TOWN OF GLASTONBURY  
GL-2020-19  
WELLES-TURNER MEMORIAL LIBRARY RENOVATIONS AND ADDITION PROJECT  
ADDENDUM NO. 2  
10/5/2020

**III. Revisions to the Drawings**

1. Replace the following drawings in their entirety:  
CS501, A2.01, A2.02, A11.01, M5.00
2. Revise the following drawings per Addendum 01, see attachment 1.  
SKA-006, SKA-007

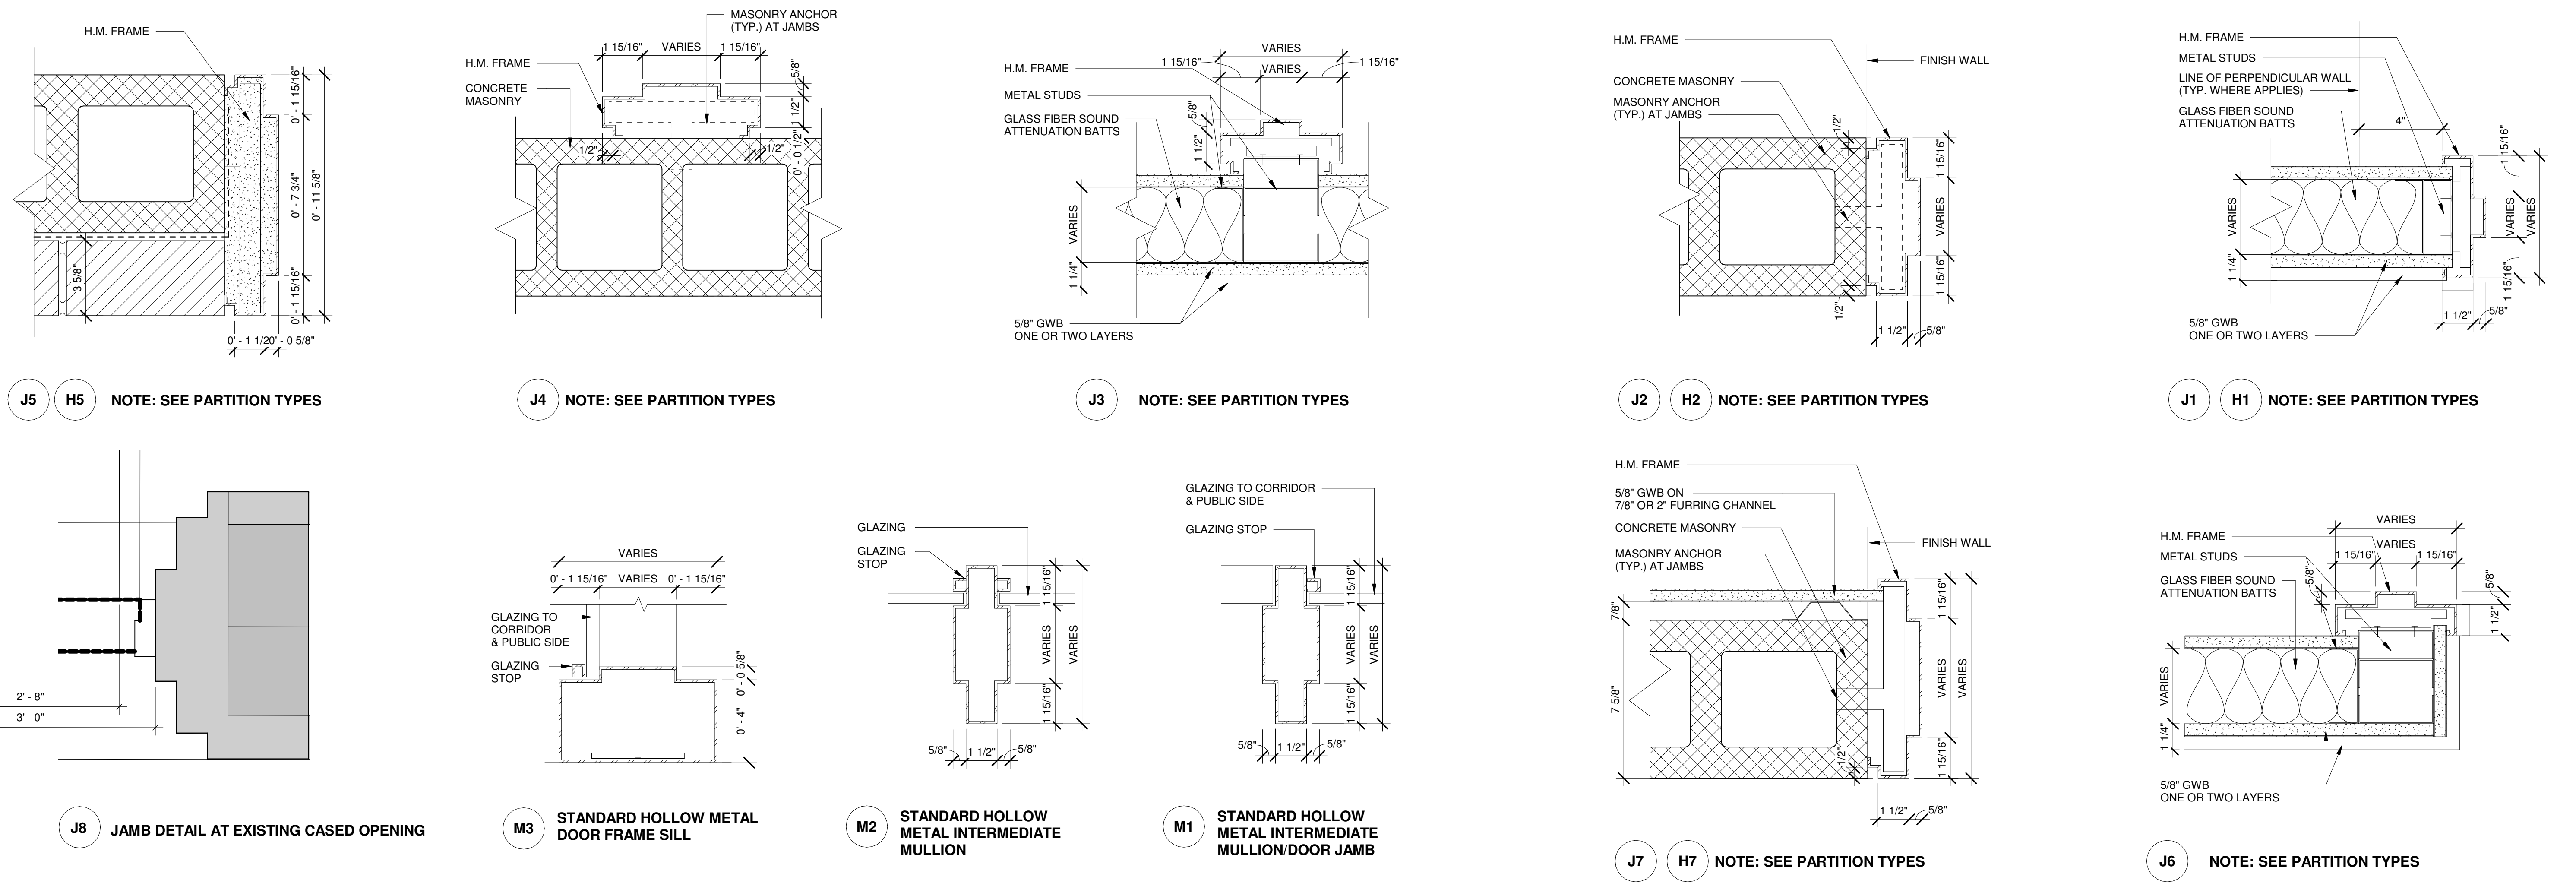
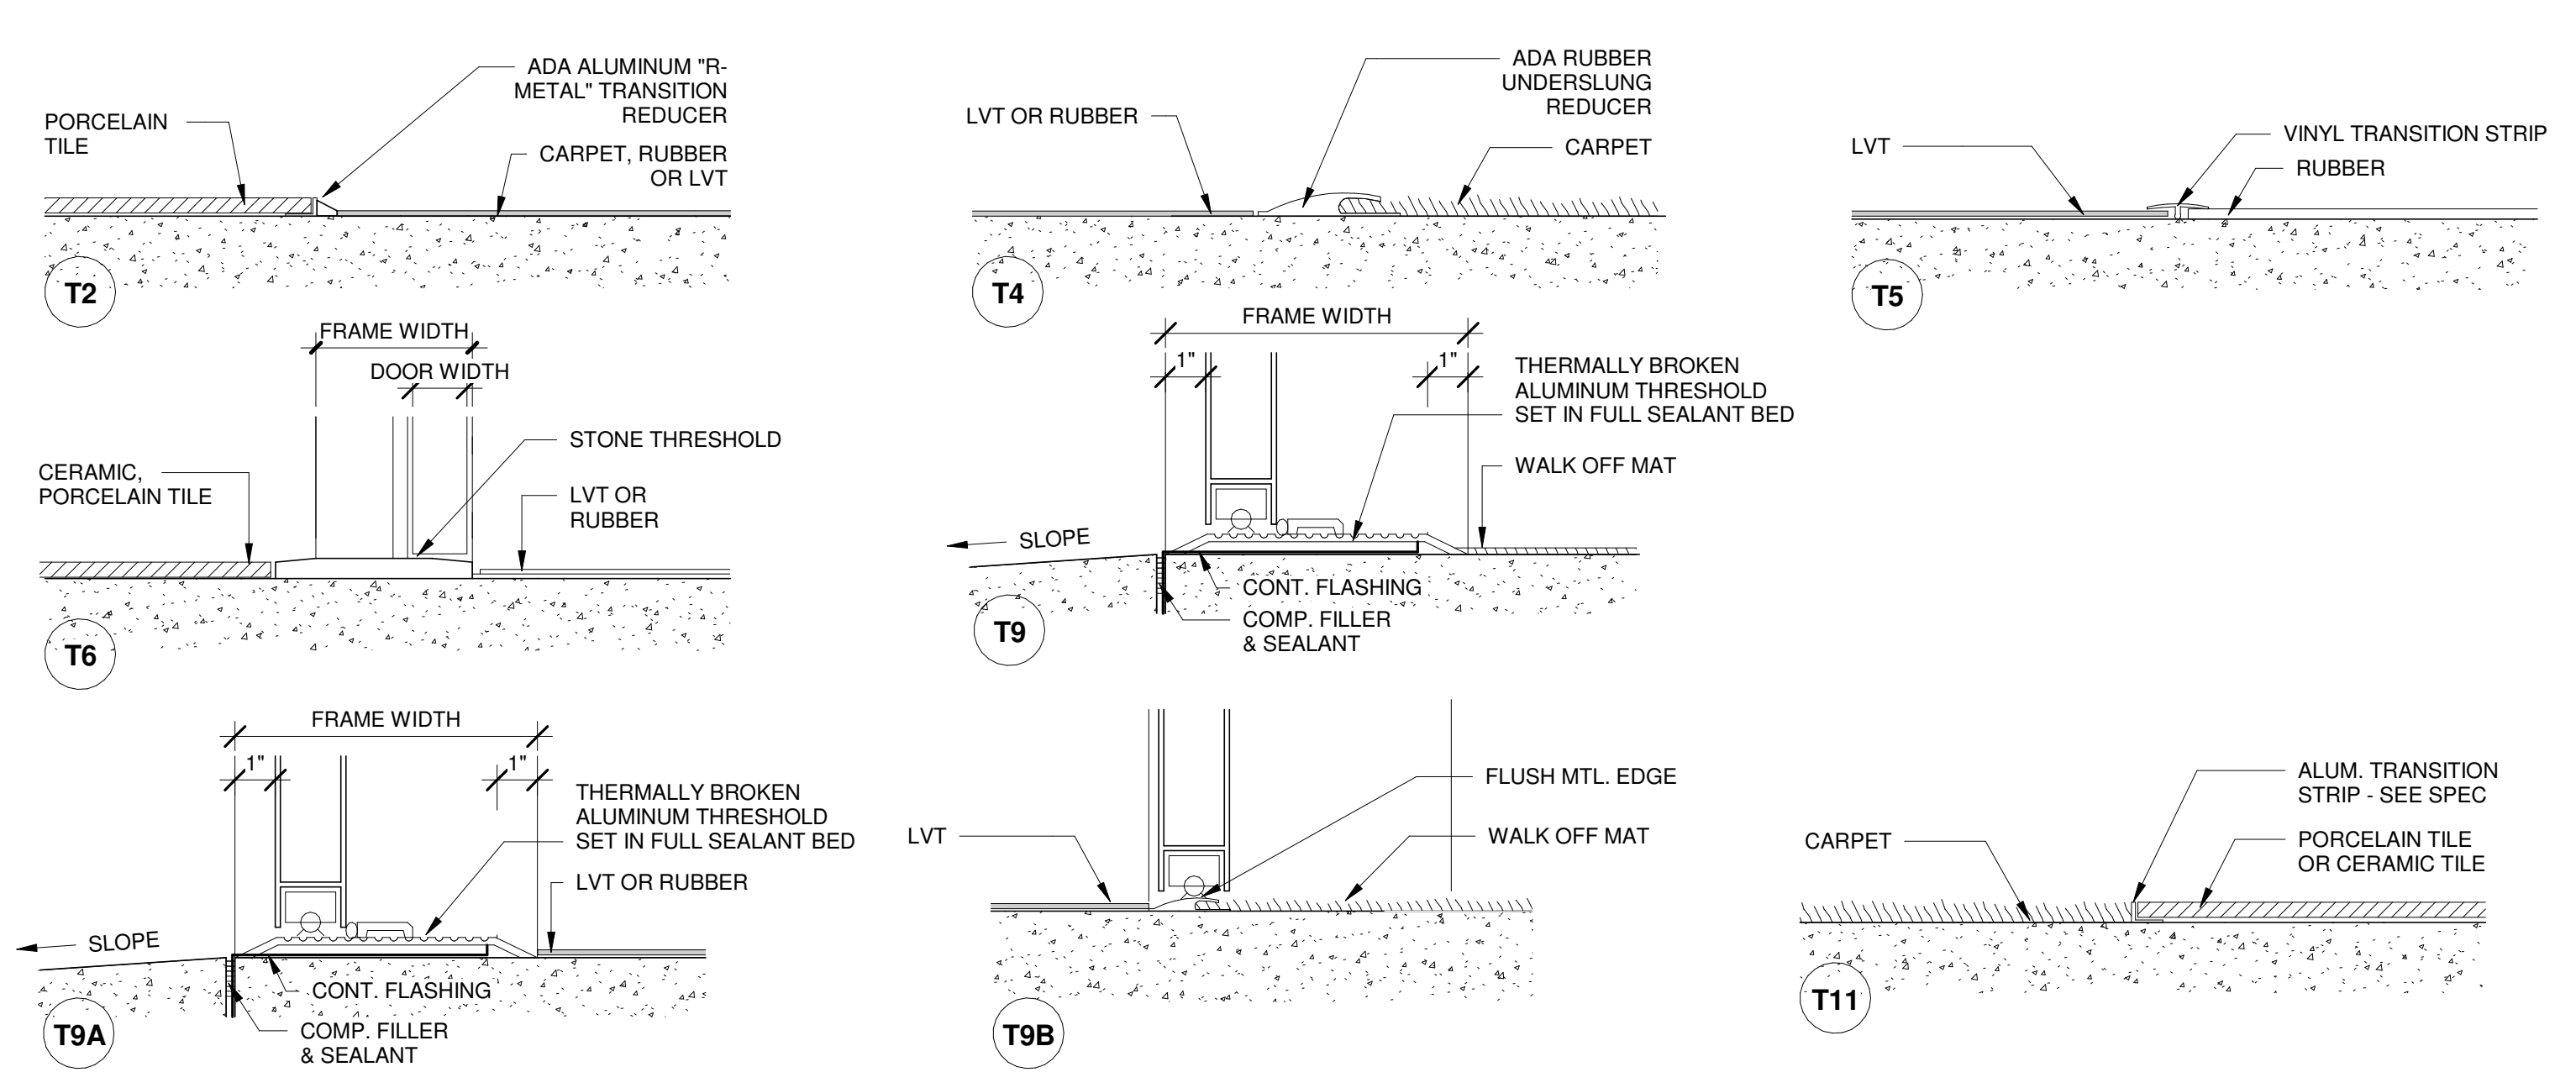
**Question 24:** *Drawing A11.01 – There is no door, frame, hardware shown for opening 176. Please advise.*

**Question 25:** *A11.01 – There are 5 openings which have “add” under Head Details. Please advise.*

**Question 27:** *Doors V261 & V261A show no frame type, the head & jamb details show HM frame, which I assume is incorrect. Can you verify the frame type is F4 and they are wood per 081433?*

**Question 28:** *Door 171A shows Aluminum frame type F5, there is no detail for F5.*

**Answer:** See Addendum #2, A11.01.

**Answer:** See Addendum #2, A11.01.

**Answer:** See Addendum #2, A11.01.

**Answer:** See Addendum #2, A11.01.

**8 SNOW MELT INSTALLATION DETAIL**  
NTS

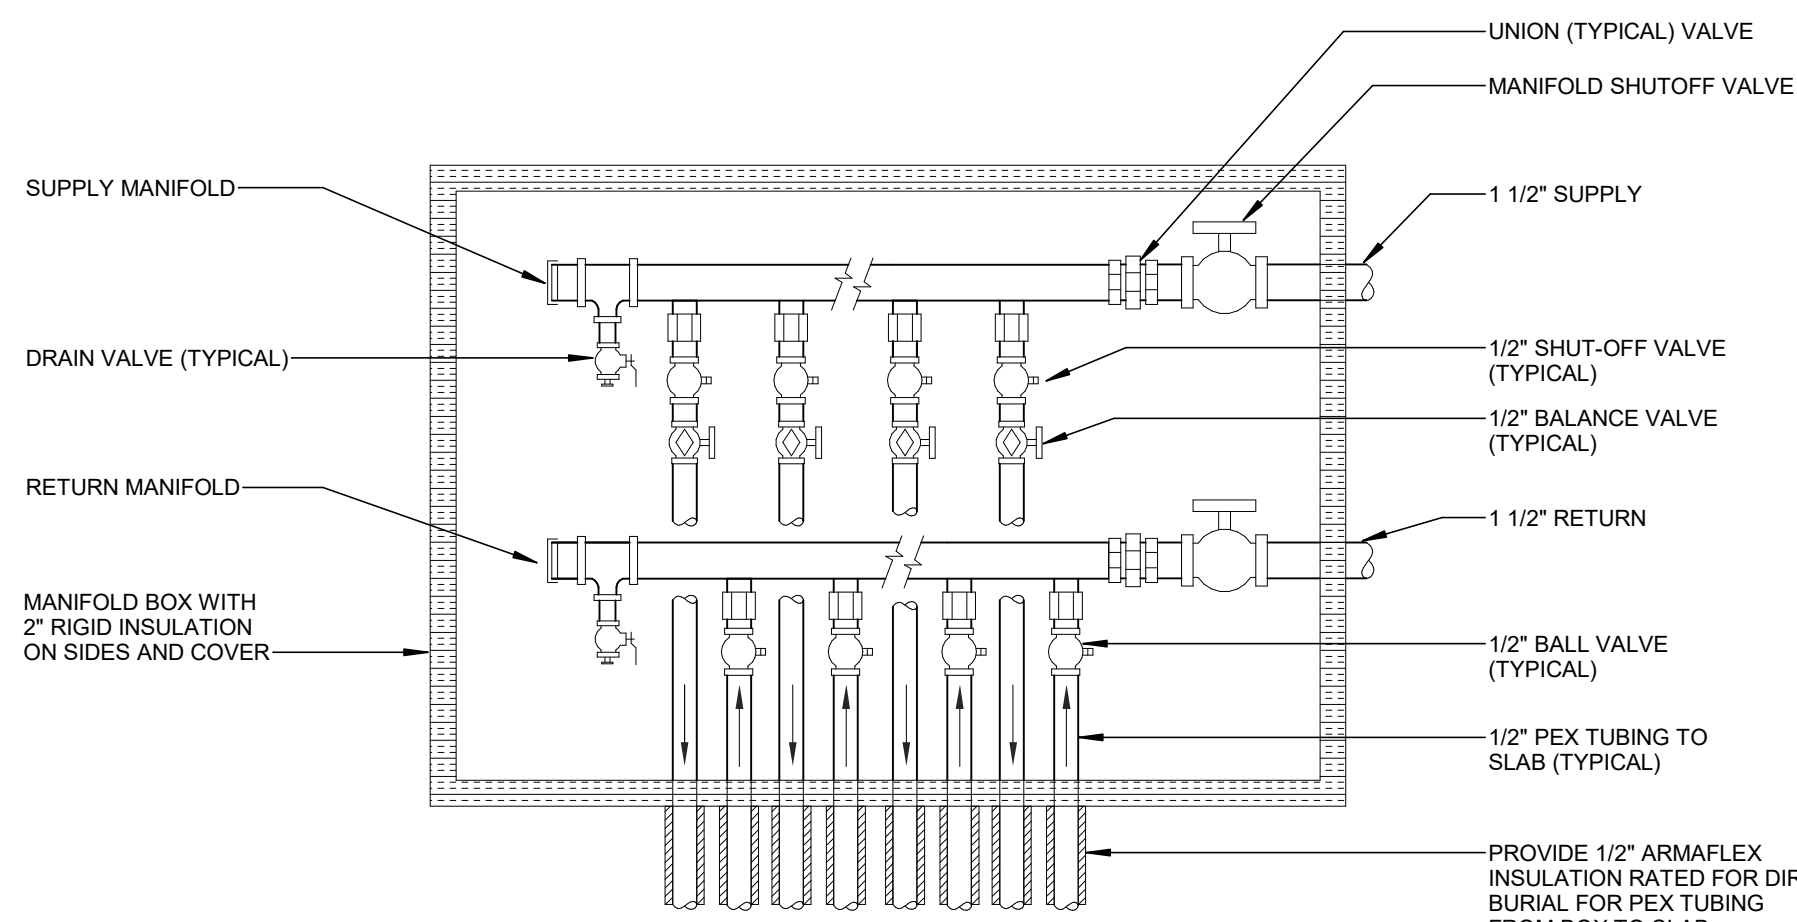
**Question 79:** *Detail 8/M5.00 – Please provide amended detail for the exterior application of the snow melt. This detail looks like an interior condition*

**Answer:** Please, refer to Addendum #2, drawing CS5.01 and M5.00 for an amended detail of the snow melt system.
